Steven M. Clouse WRC Electrical System Improvements Phase 2A

Job No.: 21-6507

ADDENDUM 2

August 10, 2021

SHEET NO.
05E05
91 OF 328

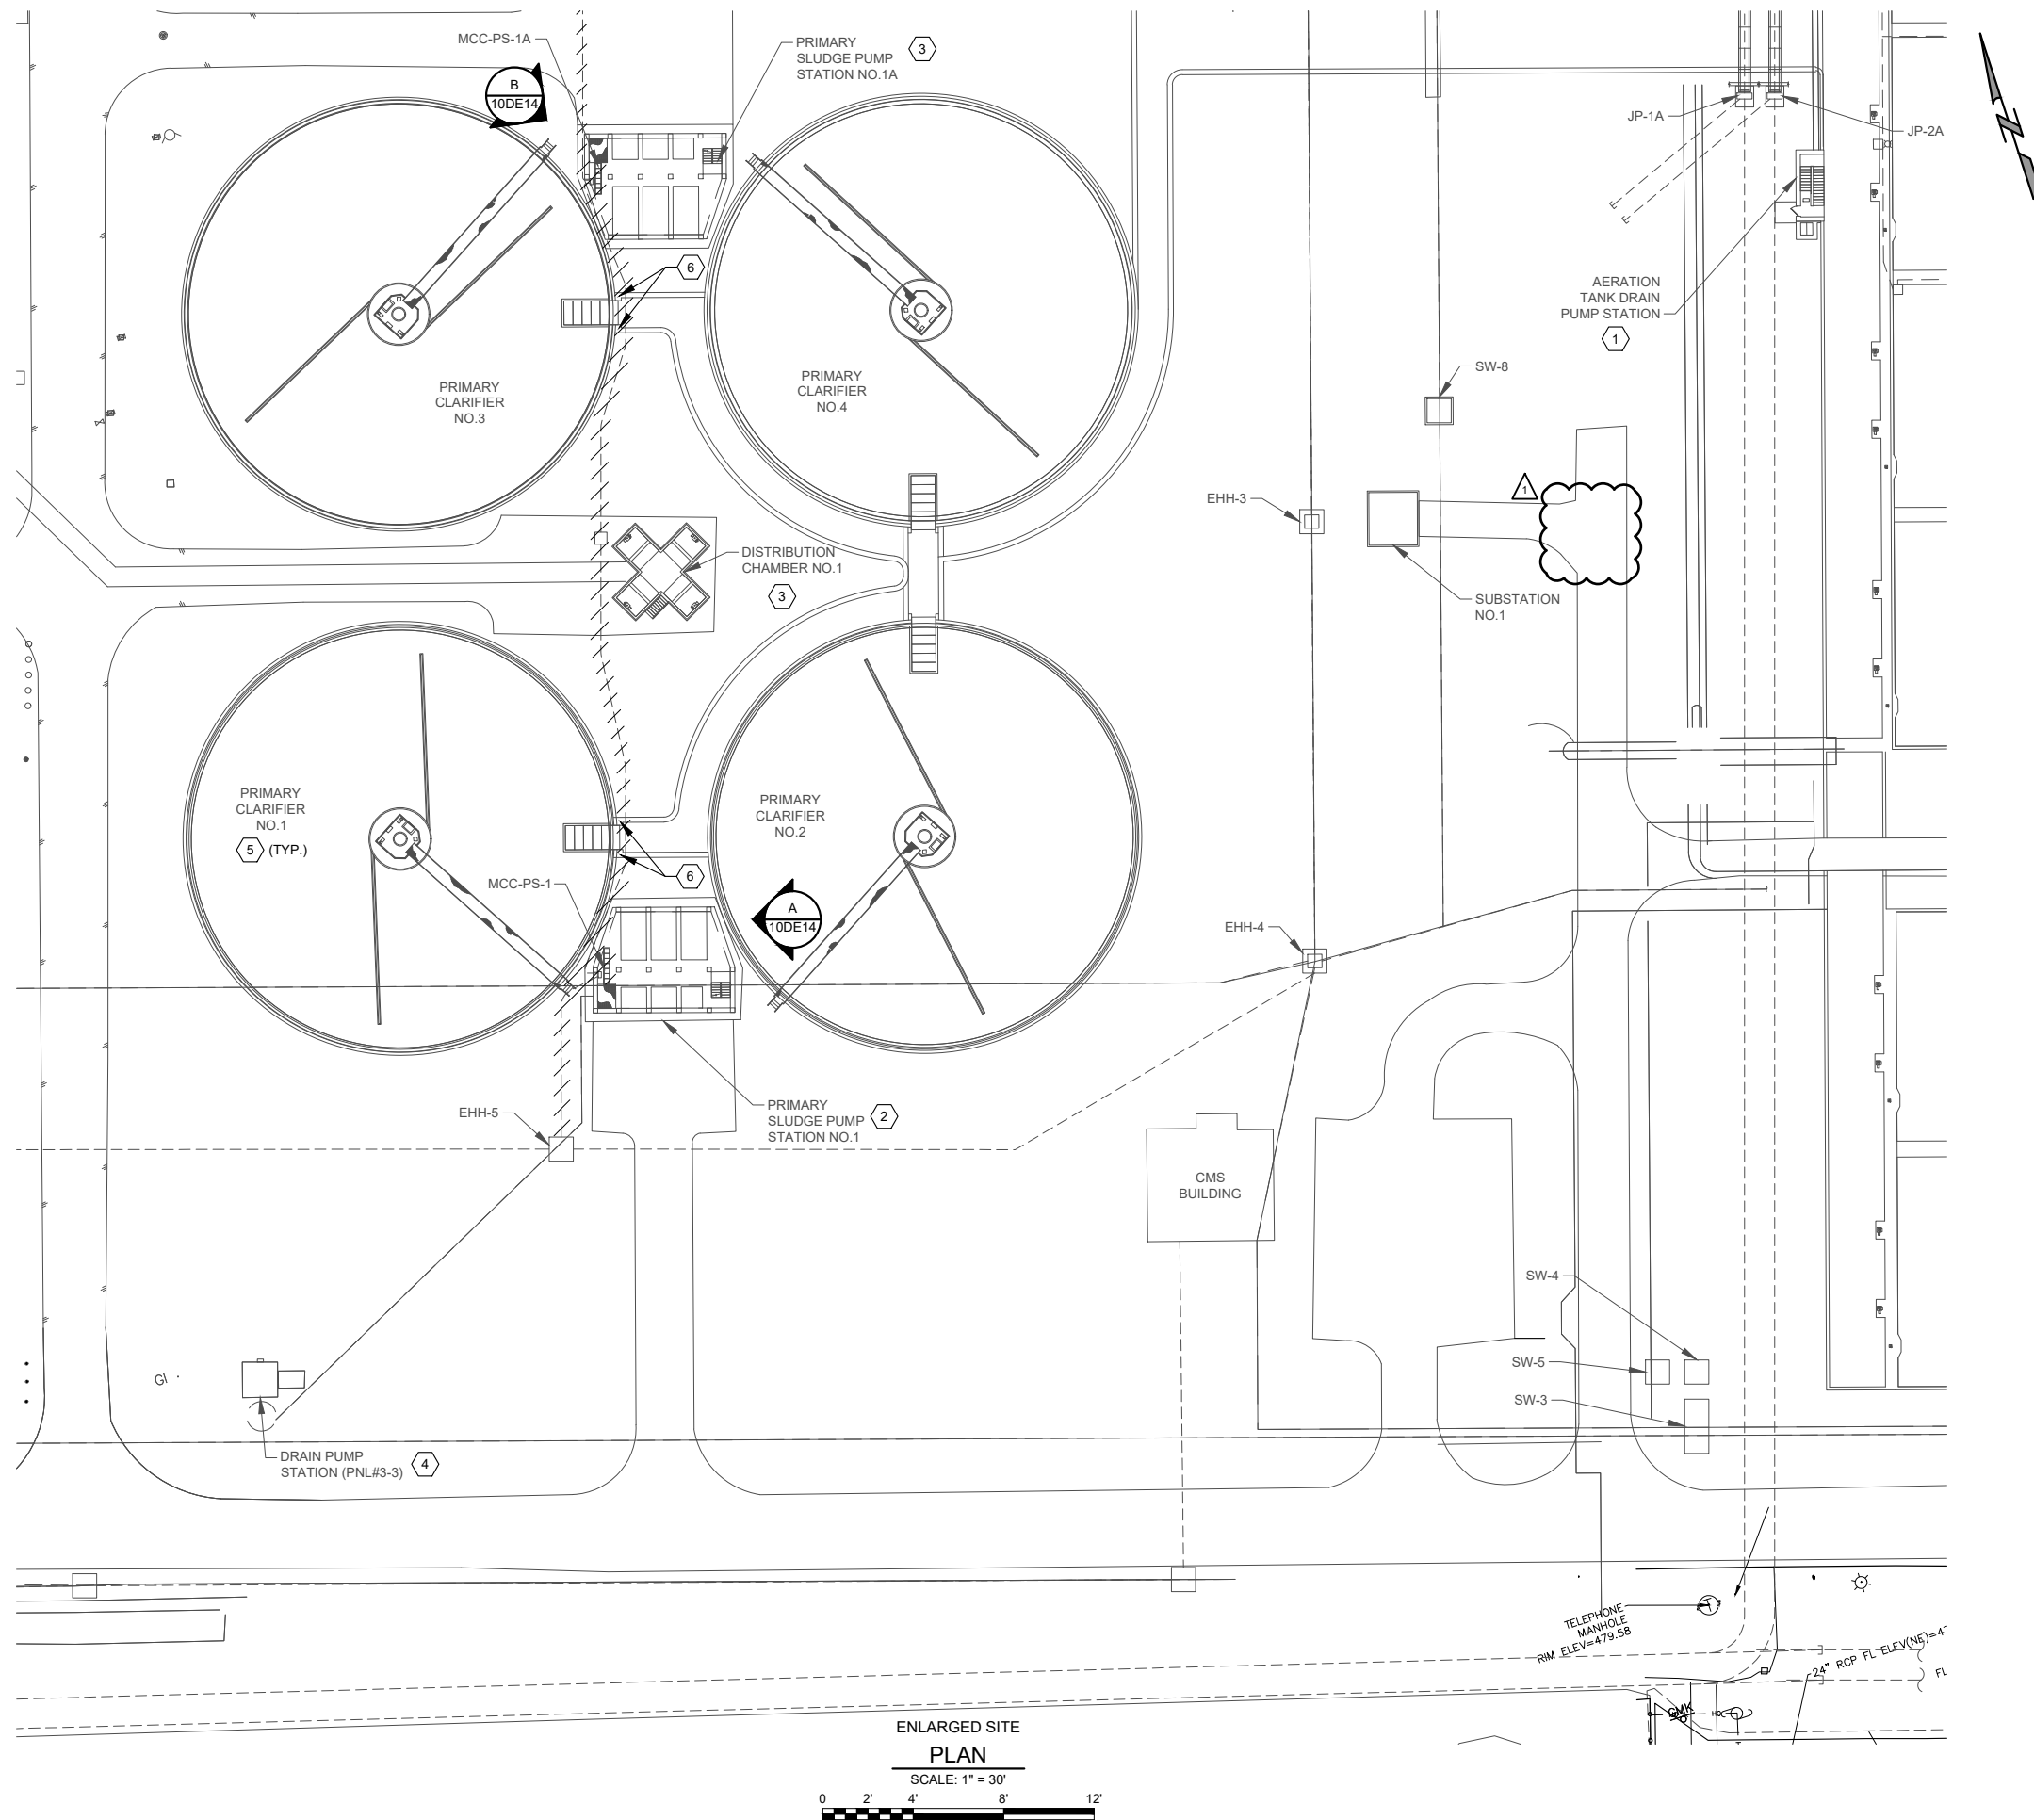
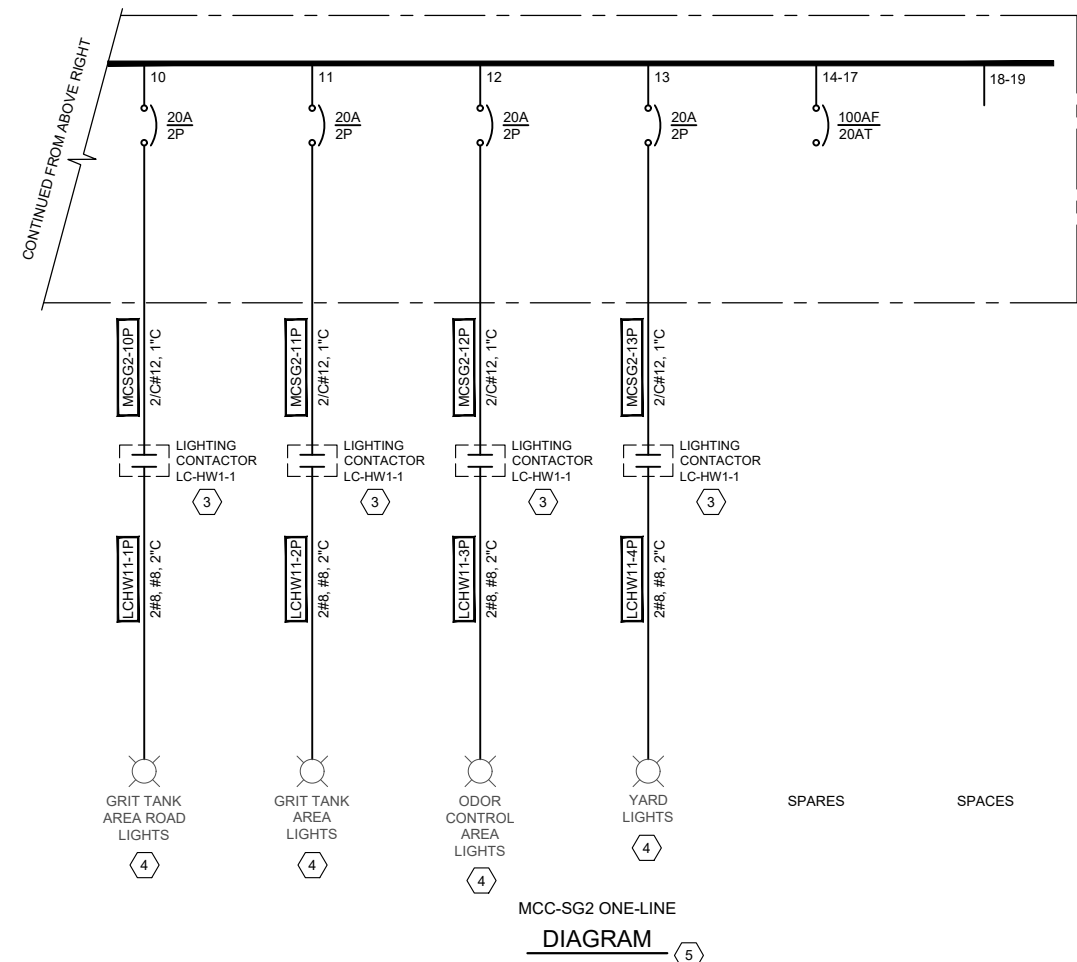
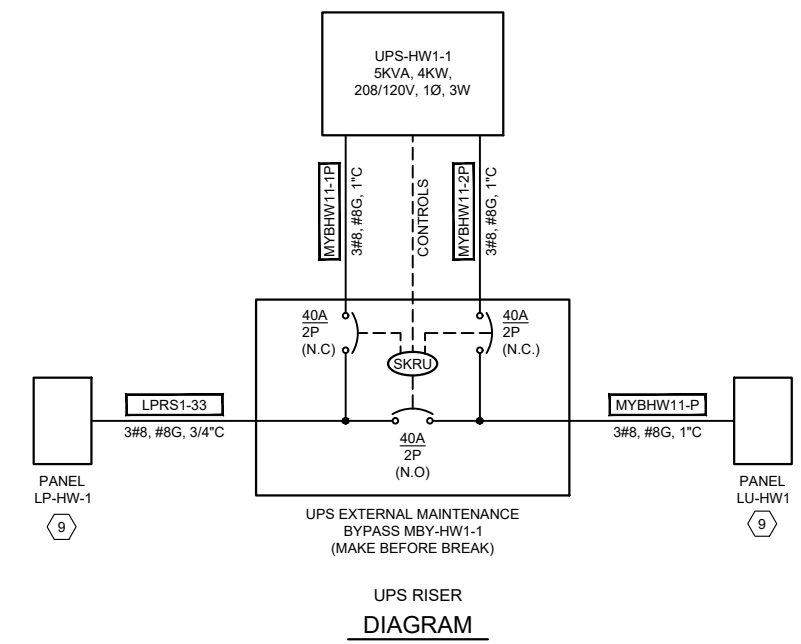
2. Please review routing of generator switchboard circuit EM1-4P to Headworks Electrical building. One-line diagram 05E05 sows it as 3(3-500KCMIL, 500KCMIL G). However, ductbank sections shows only 1 & 2 parallel feeds for this circuit. Sheet 10E33, DB section 10AM (conduit # 5), sheet 10E03, DB 10N (conduit # 5-6), sheet 05E02 DB 05C1 (conduit # 5-6), DB05C (conduit # 9-10). Please advise if the one-line is incorrect or the duct bank sections need to be revised.

Response: This feeder is two parallel runs, 4" conduit. Refer to Changes to the Plans items "d. 05E05" and "g. 10E33." (all other drawings correctly show 4-4" conduits.)

SHEET NO.
10DE01
142 OF 328

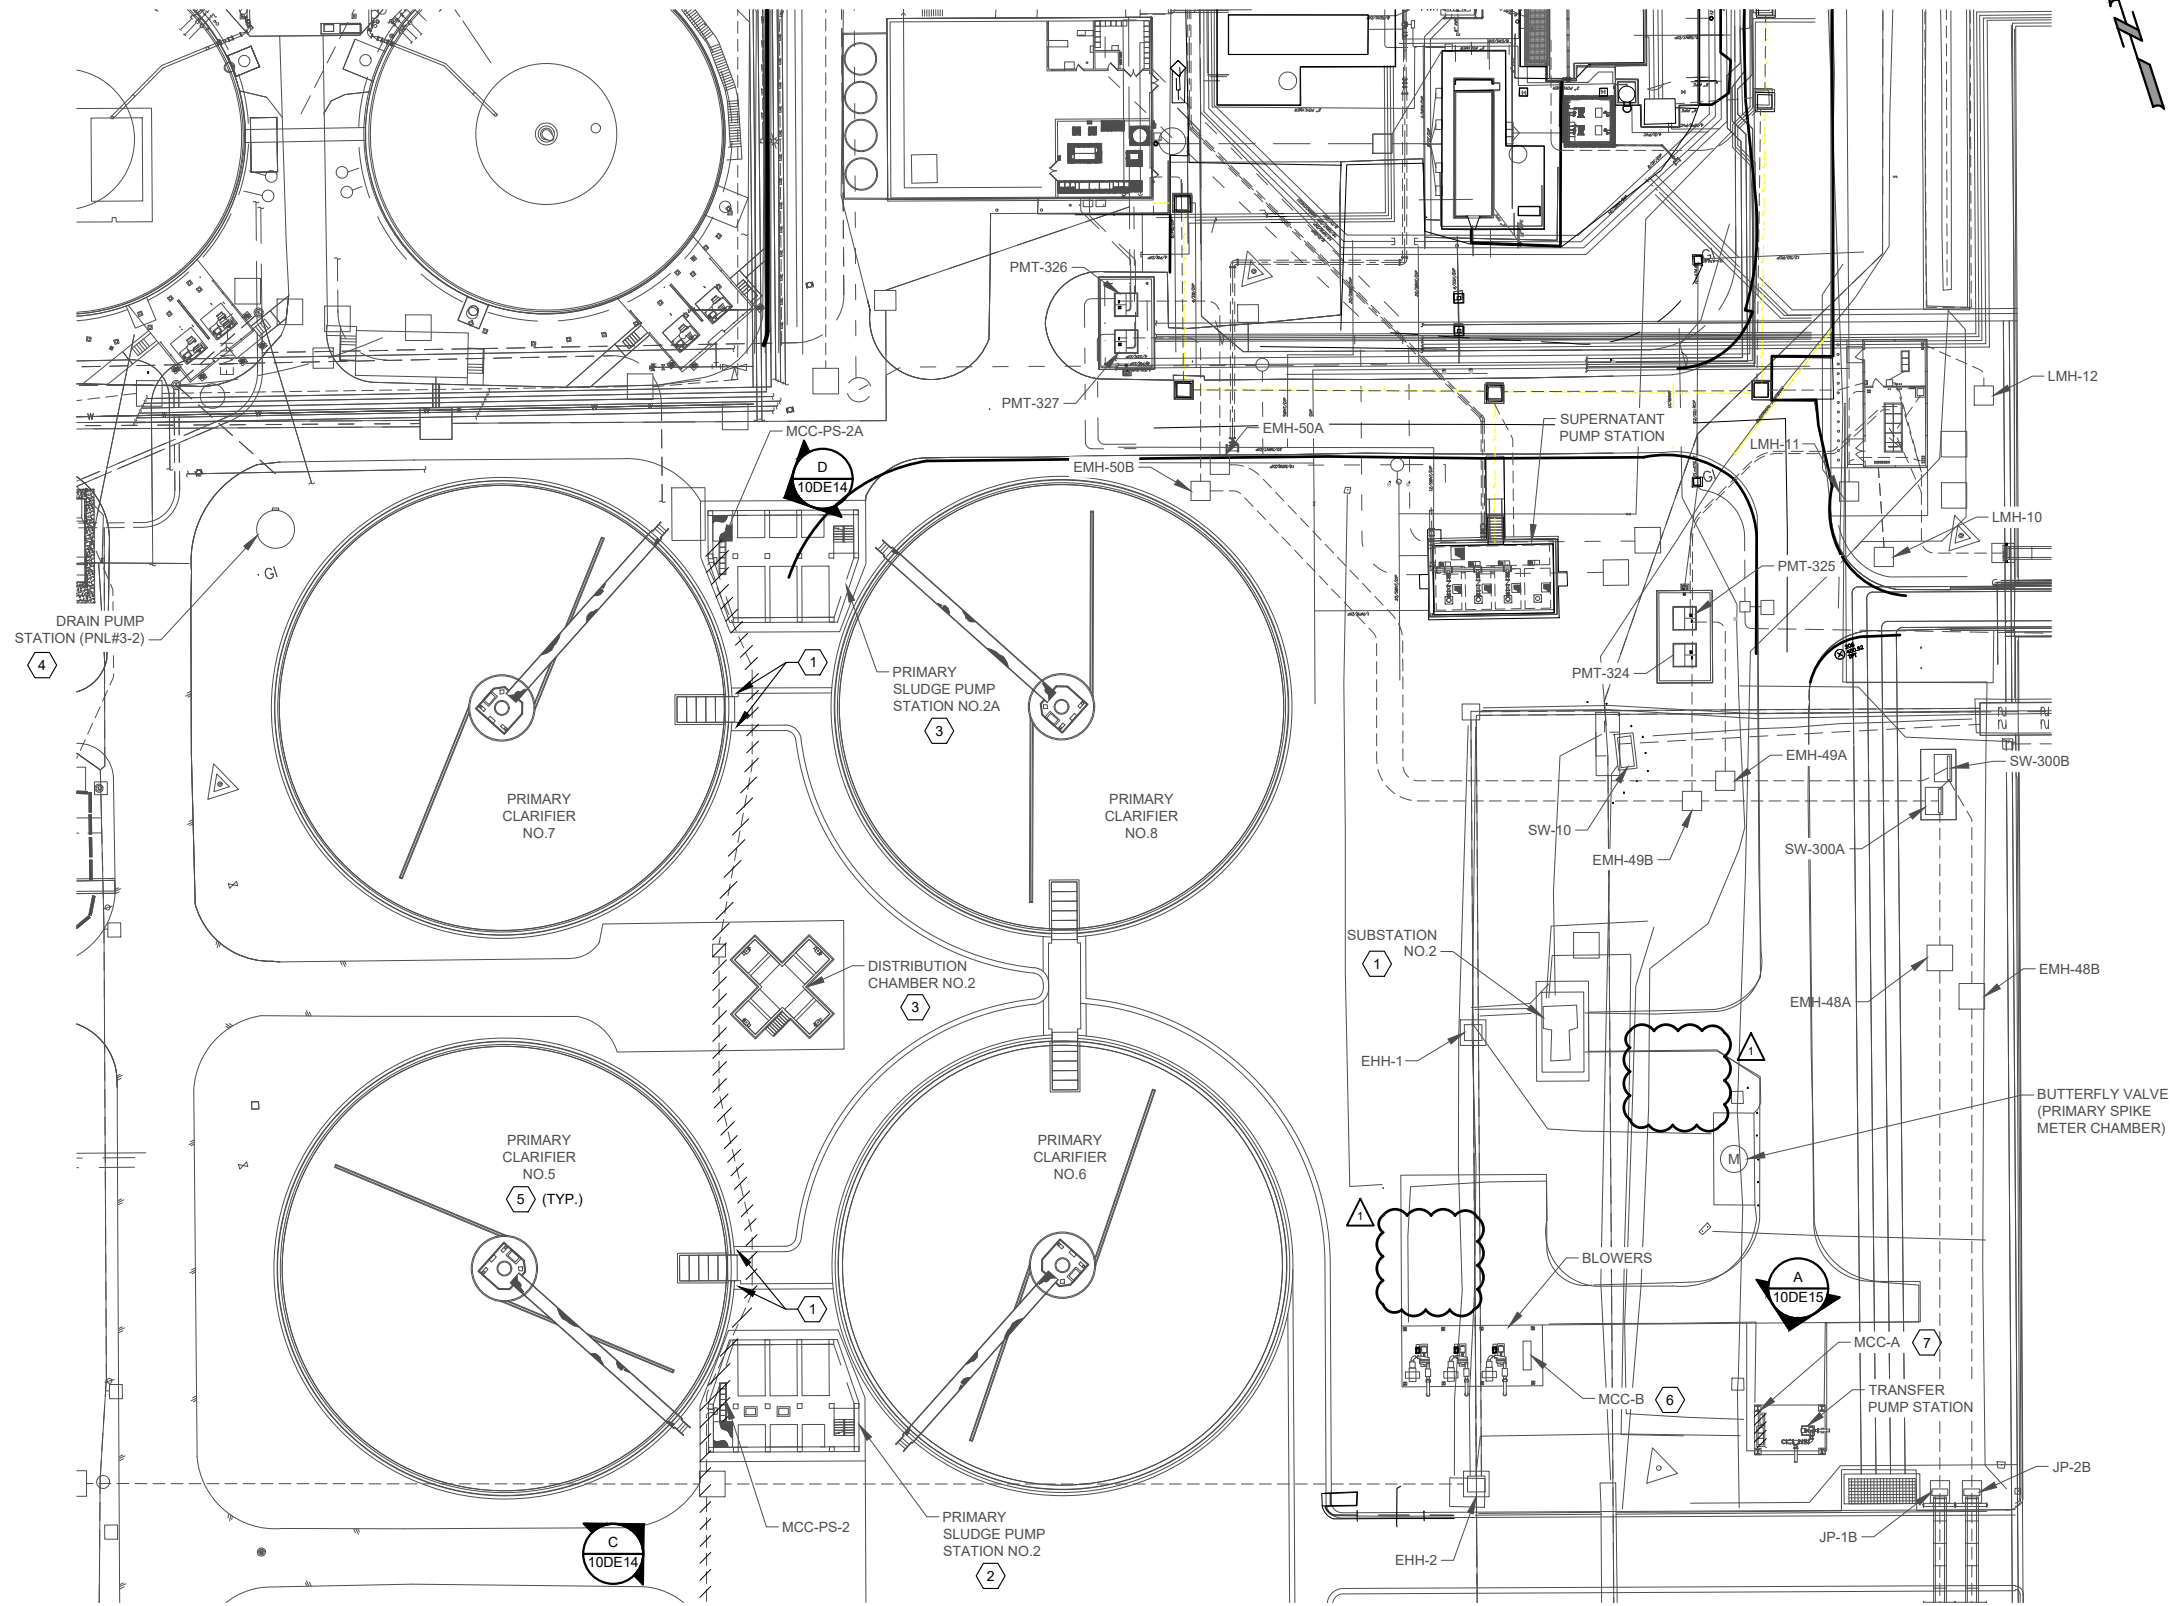
7. On Sheet 10DE01 Substation No 1 Section View F 10DE14, sheet 10DE02 MCC B Section View E and G for Substation No 2 does not exist on plans

Response: Those section (photograph) callouts were included in previous projects, and are no longer part of this project. Refer to Changes to Plans items "e. 10DE01" and "f. 10DE02."

SHEET NO.
10E33
189 OF 328

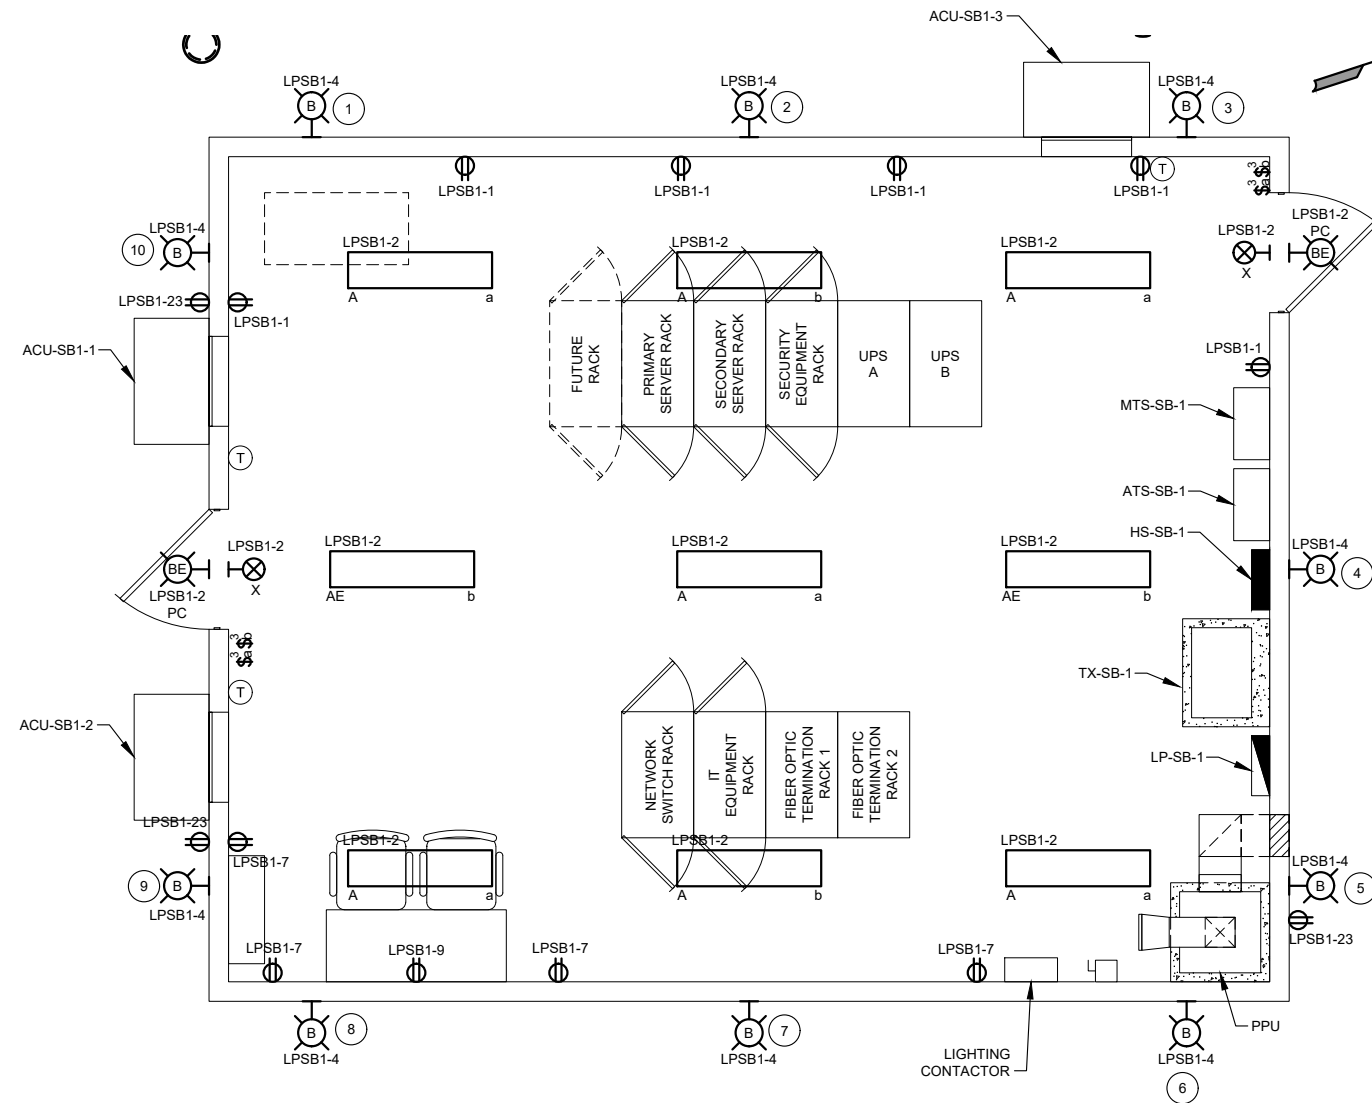
3. Sheet 10E05 ductbank section 10M Conduit # 8 & 22. These conduits contain circuits to MCC, RIO and Interlock panels in the same conduit. Similarly, conduit #19 contains circuits to LP-PS11 and LP-PS12. Please review and advise as this would increase the number of conduits in the ductbank from manhole LMH-14. Same situations occur in DB Section AQ on 10E33.

Response: These circuits don't need to be separated; they can be combined into the same conduits as shown.
